**REV A3**

Last Edited: September 23rd, 2009 - LLO

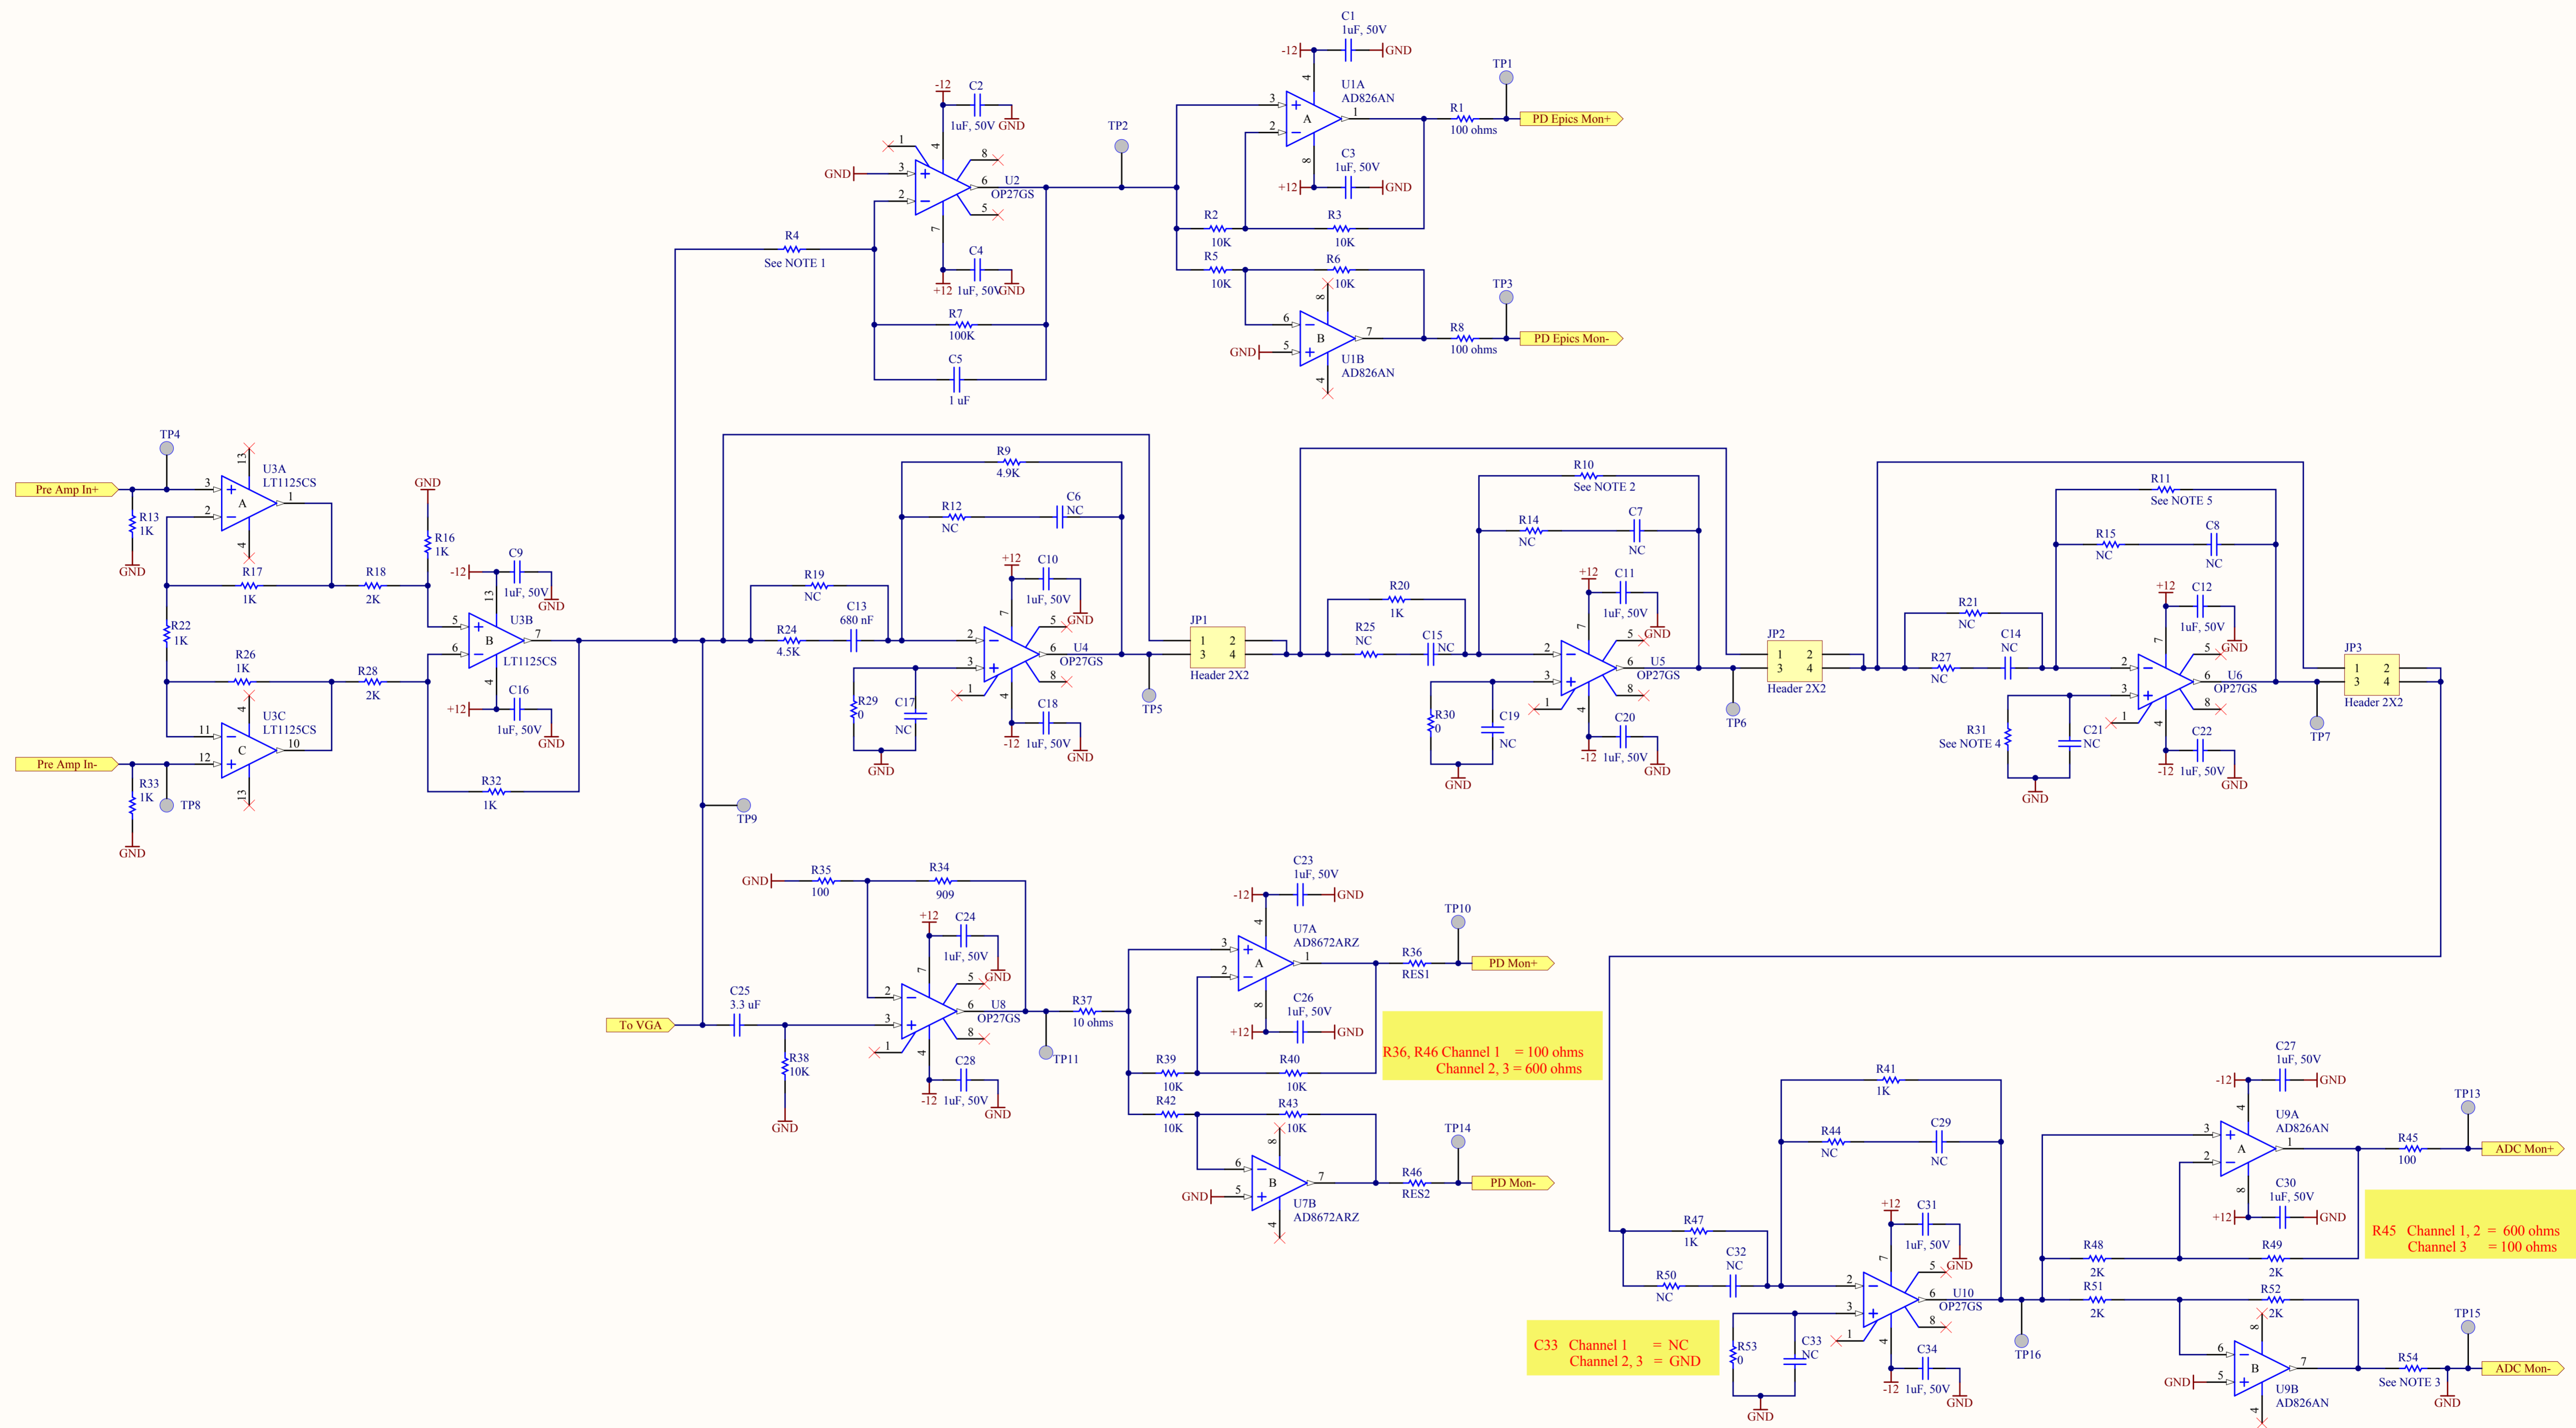
**NOTE 1**  
R4 is replaced from 100K to 200K on PD1 and PD2  
R4 is replaced from 100K to 10K on PD3 ( Y-arm )  
R4 is replaced from 100K to 2K on PD3 ( X-arm )

**NOTE 2**  
R10 is replaced from 10K to 100K on PD1 and PD2

**NOTE 3**  
R54 is removed and grounded on PD1, PD2 and PD3 ( X-arm )  
R54 is removed and grounded on PD1 and PD2 ( Y-arm )

**NOTE 4**  
R31 is 0 ohms in all the channels.

**NOTE 5**  
R11 is 0 ohms in all the channels.

**NOTE 6**  
R82 is 10K on both X and Y.

**NOTE 7**  
Port TTL In is changed to Enable/Disable  
Open = Disable GND = Enable.

Variable Gain Stage

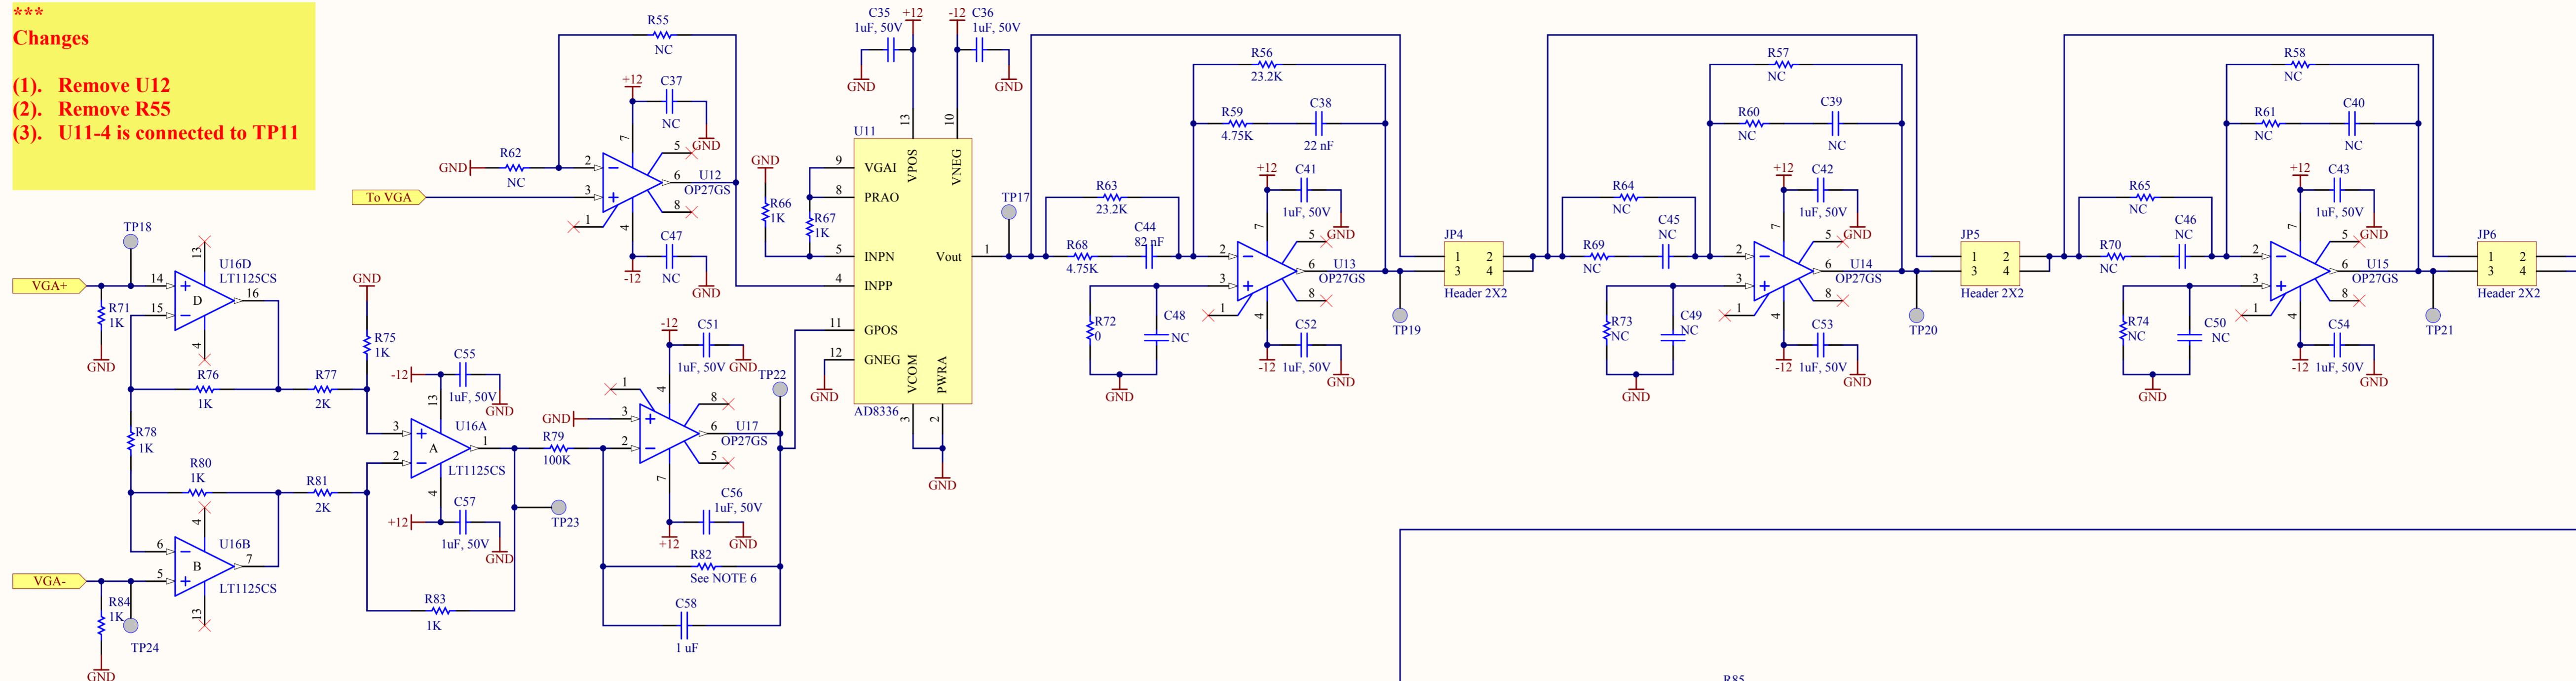
VGA needs to be AC Coupled \*\*\*

\*\*\*  
**Changes**  
 (1). Remove U12  
 (2). Remove R55  
 (3). U11-4 is connected to TP11
